Re: Florida Power & Light Company
Proposed Turkey Point Units 6 and 7
Docket Nos. 52-040 and 52-041
Supplemental Response to NRC Environmental Request for Additional Information
Letter 150211 (eRAI 8380) Related to Hydrology/Ground Water

NRC RAI Number: EIS HYD/G-Q1 (eRAI 8380)

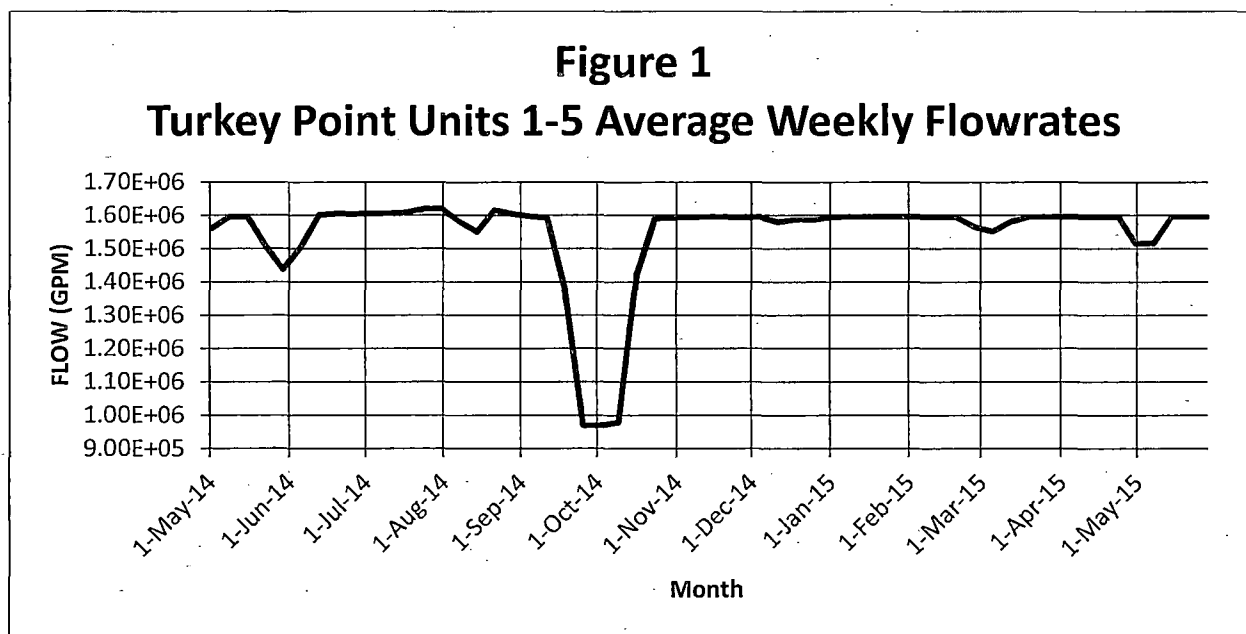
The NRC staff needs to understand how the recent changes in the operation of the IWF (Industrial Wastewater Facility) may change the environmental baseline of the affected environment in the vicinity of Units 6 and 7. Though the staff understands that the annual Extended Power Uprate Monitoring report will not be submitted to the Florida Department of Environmental Protection until spring 2016, the staff requests currently available data of recent conditions of the IWF and associated monitoring wells, including water levels, water temperature, salinity, water quality parameters, and turbidity, since May 31, 2014. Provide the existing data on past pumpage rates from various sources, including the freshwater canals and wells in the Biscayne or Upper Floridan aquifers associated with the IWF. Further, please provide a reasonable range of future pumpage rates from these sources.

Also, provide Units 3 and 4 flowrates and temperature changes at the intakes and discharges in the IWF since May 2014. Please include any data from before June 2014 that had not been included in the 2014 report.

Provide Units 3 and 4 flow rates at the intakes and discharges in the IWF since May 2014.

Operation of Turkey Point Units 1 through 4 relies on the circulation of IWF water through their respective circulating water cooling systems. Unit 5 is not supplied water from the IWF but discharges waste water to the IWF in a relatively minor amount. As described below, water flows from Units 1 through 5 were obtained and combined in a composite weekly time series of total flow rates in the IWF, as shown in Figure 1.

Units 3 and 4 cooling water flow rates are provided by four circulating water pumps plus three Intake Cooling Water (ICW) pumps per unit. The circulating water pumps are designed to operate at 156,250 gallons per minute (gpm) each and the ICW pumps are designed to operate at 16,000 gpm each.

During the period of May 1, 2014 to June 1, 2015 the combined flowrates of Units 3 and 4 were a 13 month average of 1,263,920 gpm which takes into account actual pump run times that include pump operation rotations, maintenance downtime and outages. The Unit

3 average flowrate was 652,397 gpm and Unit 4 average flowrate was 611,523 gpm for the 13 month time period.

During this same time period Units 1 and 2 were a significant contributor to IWF flowrates. Unit 1 circulating water pumps provided an average of 270,352 gpm, including cooling water pumps that provided 6000 gpm cooling for miscellaneous plant equipment. The Unit 2 cooling water pumps provided an average of 6000 gpm to the IWF. Unit 2 had no large circulating water flowrates since it has not been operated as a power production facility since 2011 but instead has been operating as a synchronous condenser.

Unit 5 discharged blowdown water from cooling towers and waste water sumps to the IWF at an average rate of 4746 gpm.

The combined total average water flowrates for Units 1 through 5 pumped to the IWF was 1,545,018 gpm during the 13 month period.
